Figure 3: Interim Report network modelled

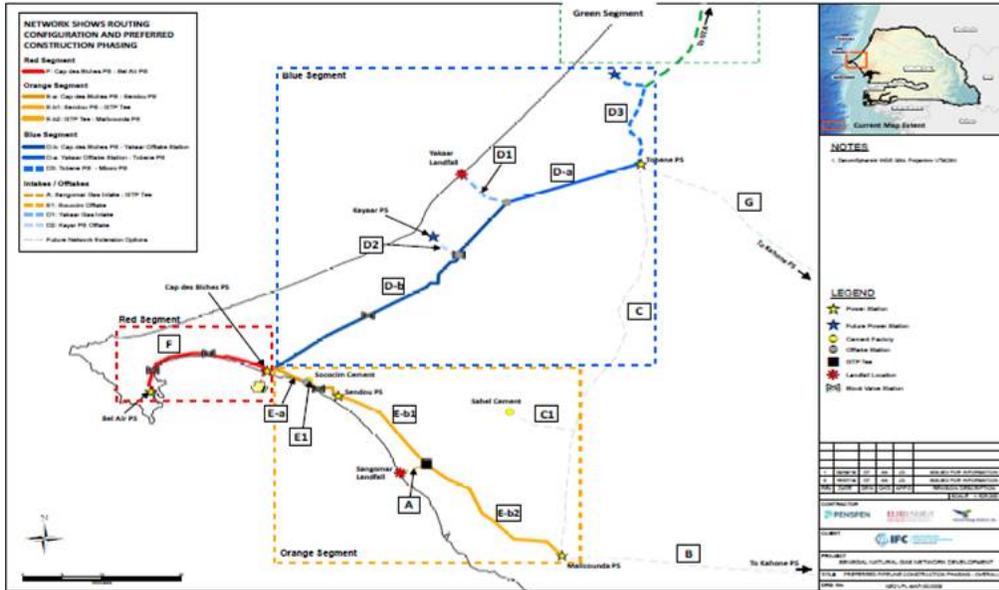
Question: Please clarify the size of the pipeline segments identified at IFC Pre-Feasibility Study.
Answer: The IFC Pre-Feasibility Study suggested a pipeline diameter of 24 inches, but a smaller diameter (e.g. 16 inches) may be sufficient for proposed demand through 2030. **The feasibility study should determine what pipeline diameter is necessary.**

The chart below was included in the IFC Pre-Feasibility Study. Please note, per the RFP that the most likely scenario is that gas will be provided directly from Yakaar. However, per the information in the RFP, a floating storage regasification unit (“FSRU”) is proposed for Cap des Biches to supply gas for meeting the power generation schedule of Senelec and the IPPs. The final decision on the FSRU is pending, and all aspects of the FSRU are outside of the scope of the review. **The connection after the gas meter to the main section of the pipeline is included in the feasibility study. In addition, a pipeline branch capable of managing the injection of gas at that point is included in the feasibility study.** Notably, an FSRU is also proposed for Bel Air for a direct connection to the power plant there. Alternatively, the Bel Air power plant may also be connected to the pipeline and could be a third source of gas to the pipeline network. This pipeline section is also included in the scope from the power plant at Bel Air to the network connection point at Cap des Biches. In summary, there are three current sources of gas planned to supply the pipeline network.

- Yakaar offshore field (FID is pending);
- An FSRU at Cap des Biches (the decision is pending); and
- An FSRU at Bel Air (this FSRU will serve the Bel Air power plant only; however, the pipeline will also connect to the Bel Air power plant, and we assume this FSRU can also provide gas to the pipeline.)

The connection from these three potential gas sources is included in the scope of the feasibility study but no analysis in the scope is included regarding the viability of advisability of FSRUs.

Figure 3: Interim Report network modelled

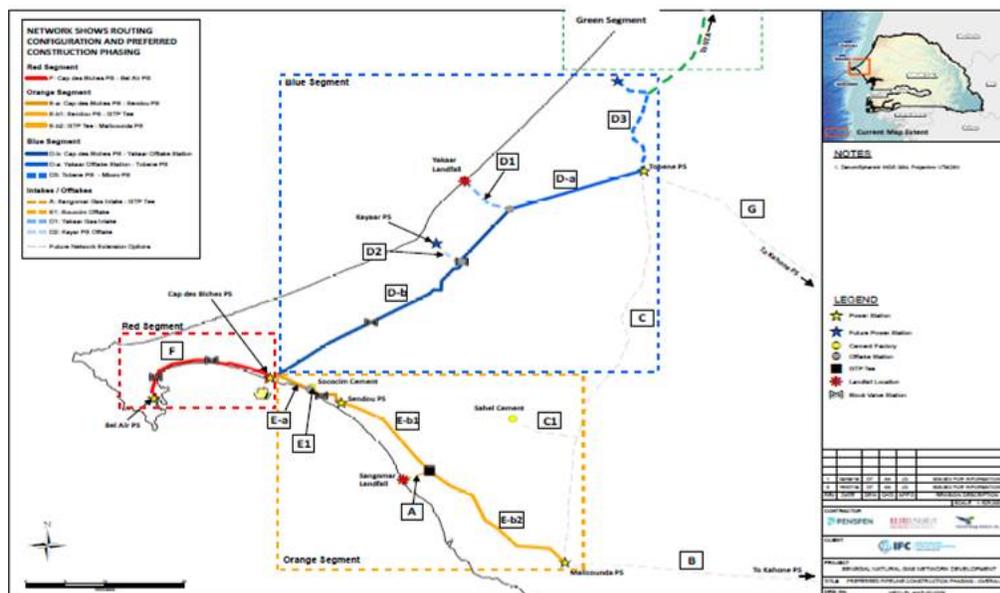
Question: Please confirm that the pipeline segments shown in dashed line in the network schematic are part of the scope of work.

Answer: The pipeline segments that are dashed are included with the exception of the connection from Tobène to Saint-Louis (dashed green) - this segment will be developed at a later stage (see schematic below). Per the Terms of Reference for the feasibility study, there are three segments that the scope of work will include:

1. Cap des Biches to Tobene/Mboro, including the gas landing point at Yakaar (Sometimes referred to as the "Blue Section");
2. Cap des Biches to Malicounda, (Sometimes referred to as the "Orange Section"); and
3. Cap des Biches to Bel Air (Sometimes referred to as the "Red Section").

The fourth section of the pipeline network, the Tobène to St Louis (the Northern Section; sometimes referred to as the "Green Section") – denoted by the green dashed line in the schematic below - is not included in the scope of the feasibility study.

Figure 3: Interim Report network modelled

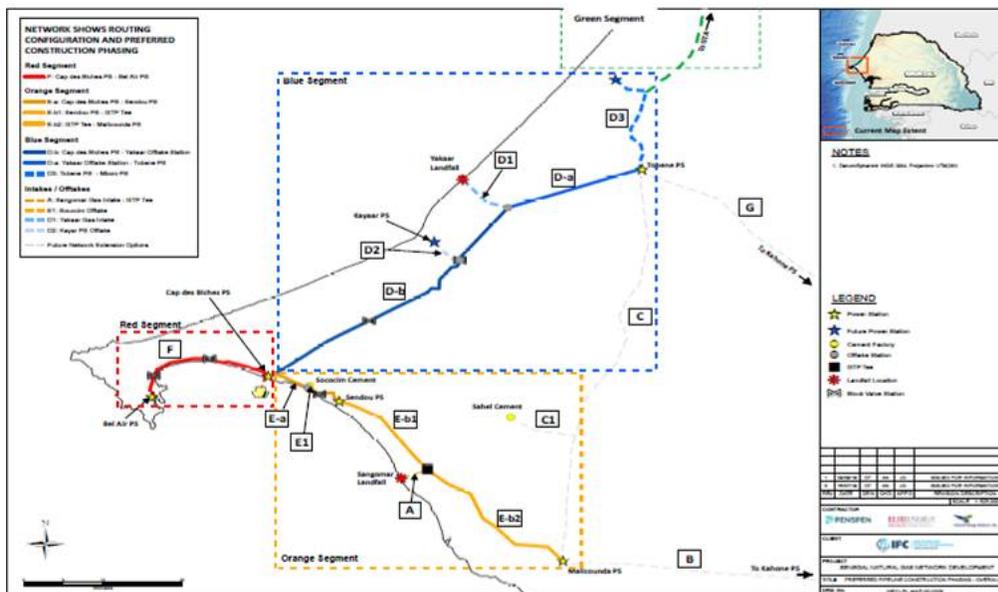
Question: Subtask 2.3 of the TOR states that the contractor shall review several possible routes that were identified in the Pre-Feasibility study. Please provide more detail on the number of possible routes and their locations

Answer: The possible routes that the feasibility study should consider are identified in the chart below, including the dashed routes (except the dashed green route). However, the Contractor shall review the recommended pipeline routes and make adjustments that provide for better, more efficient routes. Also, as the decision of connecting an FSRU at Bel Air will impact the gas flow, and the cost of installation of a pipeline through the Dakar city and suburbs may be prohibitive, the feasibility study needs to address the impact of the FSRU being connected to the pipeline at all. If there is no connection of an FSRU, then the gas introduced at Yankaar will be the sole source of gas into the pipeline, resulting in a different, more direct route away from Dakar.
